Memo

From	Richard Measures
To	Arzan Irani, Department of Conservation
Date	5 May 2025
NIWA Project	SCJ255GOV/08F
NIWA Report No.	2025107CH
Subject	Review of PDP memorandum relating to Aqualinc report for Lower Selwyn Huts

Figure 1: Comparison of sea level rise projections presented in the Aqualinc report and PDP memorandum.

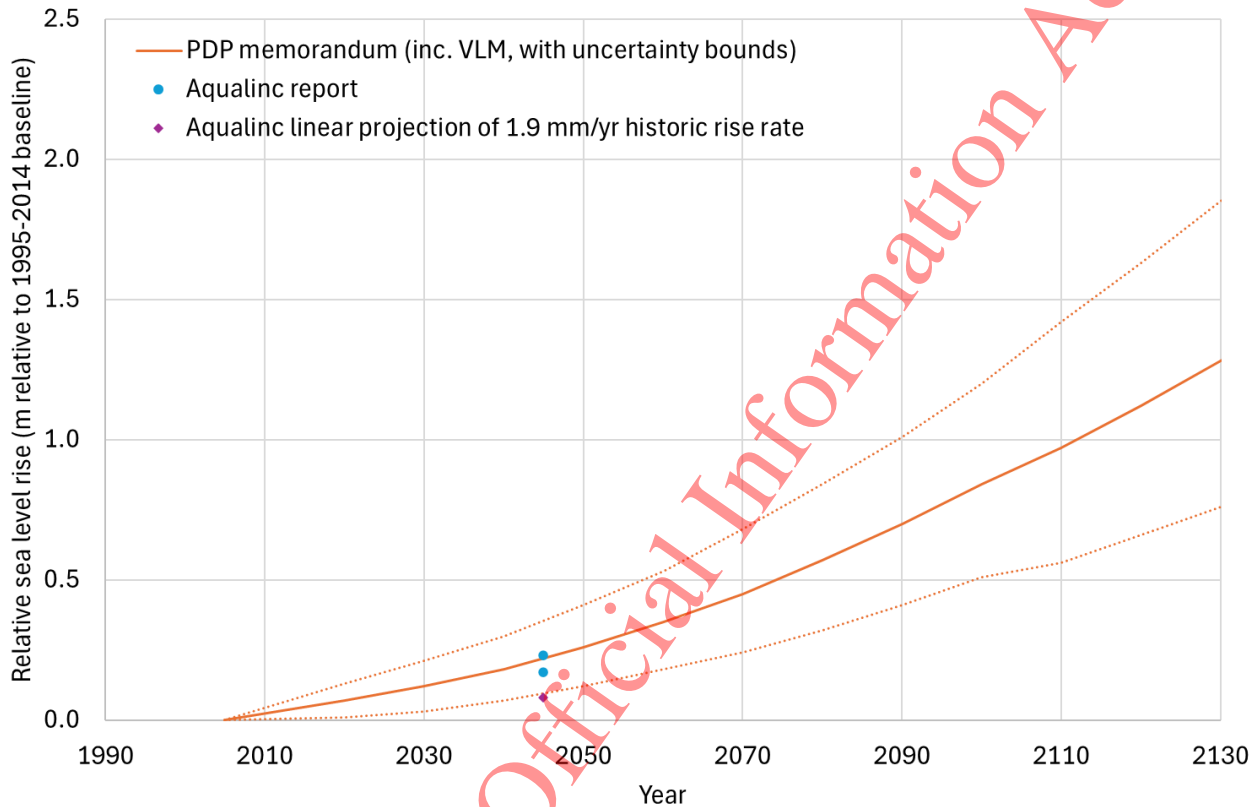
Sea level rise projections from both reports are compared in Figure 1. The sea level rise projections in both reports are relatively consistent, although the PDP report is more recent than the Aqualinc report so has updated data and guidance available to inform its analysis. For this reason, **the PDP reported projections of sea level rise are preferred**. The Aqualinc report also presents a lower bound projection of sea level rise based on continuation of a linear 1.9 mm/yr sea level rise. This lower bound is not realistic as there is strong evidence for accelerating sea level rise, and 1.9 mm/yr is lower than the observed historic sea level rise rate at Lyttelton of 2.3 mm/yr (Bell et al. 2022). **The lower bound for sea level rise presented in the Aqualinc report should be ignored.**

Figure 2: LiDAR ground elevation data for Lower Selwyn Huts. Data sourced from the [LINZ Data Service](#) and licensed for reuse under the [CC BY 4.0](#) licence.

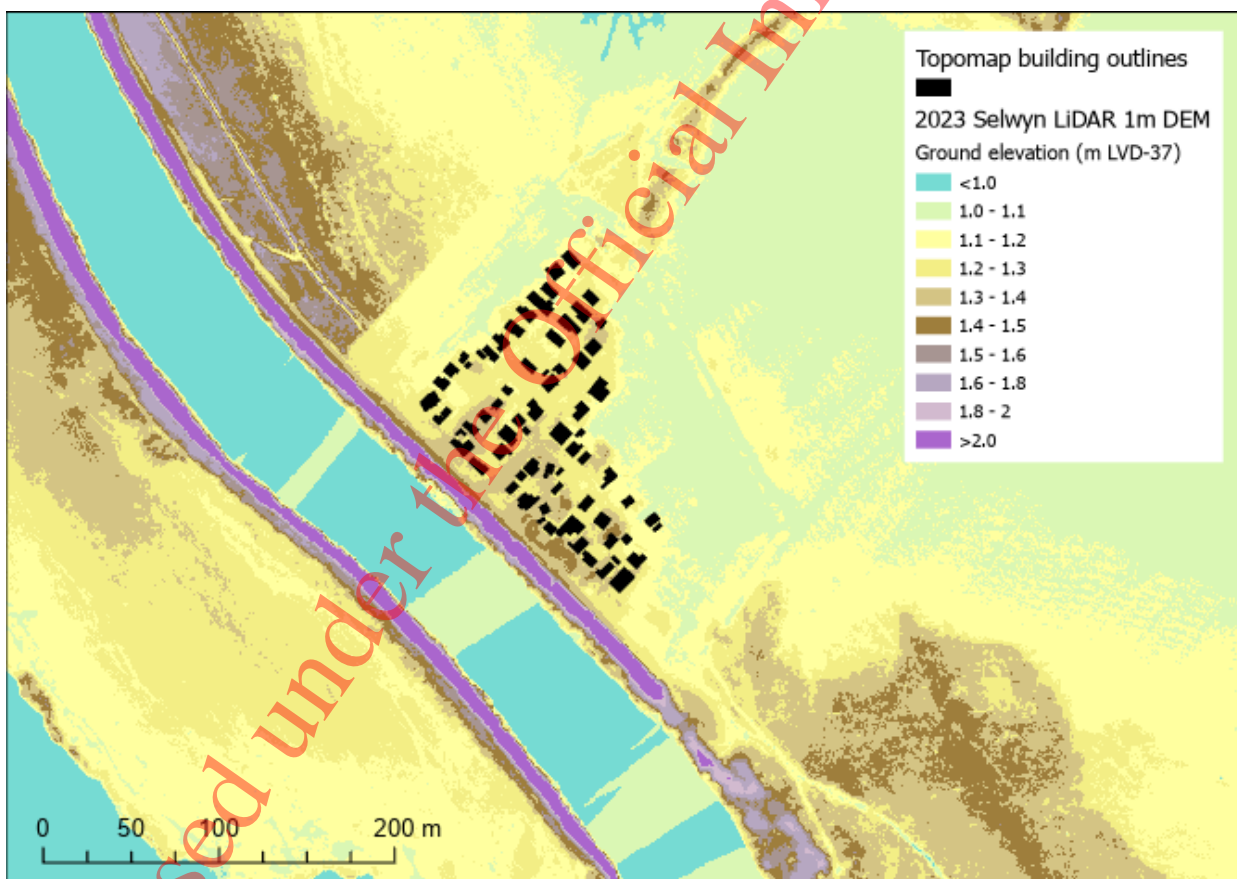
Vertical Datum 1937 (LVD-37) (in both reports; although it is ambiguously labelled “above sea level, as” in the Aqualinc report which leads to confusion in their analysis of the linkage between sea level rise and lake opening thresholds), and ground level is presented in New Zealand Vertical Datum 2016 (NZVD-2016) in the PDP memorandum. This inconsistency makes it impossible to assess how potential future sea levels and lake levels are likely to affect Lower Selwyn Huts.

LINZ provide datum conversion data between LVD-37 and NZVD-2016 (LINZ 2025). For Lower Selwyn Huts, the conversion is 0.323 m. For example, a lake level of 1.800 m LVD-37 is equivalent to 1.477 m NZVD-2016.

Te Waihora levels are monitored by Environment Canterbury in m LVD-37, and these measurements are widely used so it makes sense to convert all data into LVD-37. Converting the LiDAR data (as presented in the PDP memorandum) from NZVD-2016 into LVD-37 provides information on the lake level at which ground around the Lower Selwyn Huts will flood (Figure 2). Ground elevations around the buildings in Lower Selwyn Huts range from approximately 1.15 to 1.45 m LVD-37 (0.83 to 1.13 m NZVD-2016). The LiDAR elevation data is accurate to approximately ± 0.1 m. **The statement regarding ground elevations lying between -0.5 and +0.5 m NZVD-2016 in the PDP memorandum is incorrect.** The huts themselves are raised above ground level to varying degrees and there are no data on the floor level of the huts to estimate at what lake level each of the huts would be inundated.

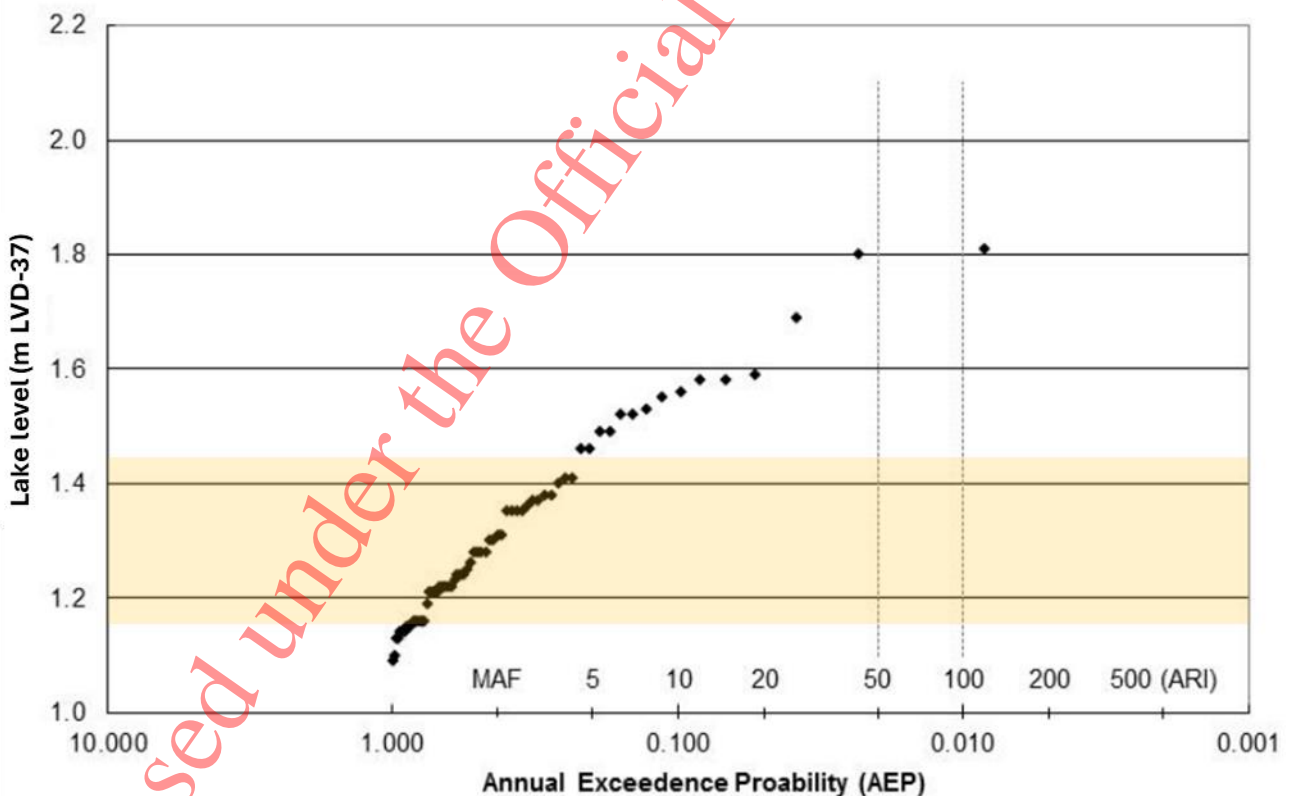
Neither report analyses the frequency with which different historic lake levels have been observed to quantify flood risk to Lower Selwyn Huts. Informing statistical estimates of the likelihood of flooding is one of the recommendations identified in the PDP memorandum. What the memorandum fails to identify is that this **lake level frequency analysis has already been conducted by Environment Canterbury and published in a publicly available report (Wild 2019)**. This frequency analysis is based off the historic period 1947 to 2013, representing the time over which the current opening method (i.e., mechanical opening) for the outlet has been in place.

Figure 3 compares this frequency analysis with the LiDAR derived ground elevation data around Lower Selwyn Huts, showing that **historically, some surface flooding around the huts has occurred most but not every year, and complete surface flooding around most of the huts has occurred on average approximately every five years**. The frequency with which the huts themselves flood cannot be calculated without accurate floor level data.
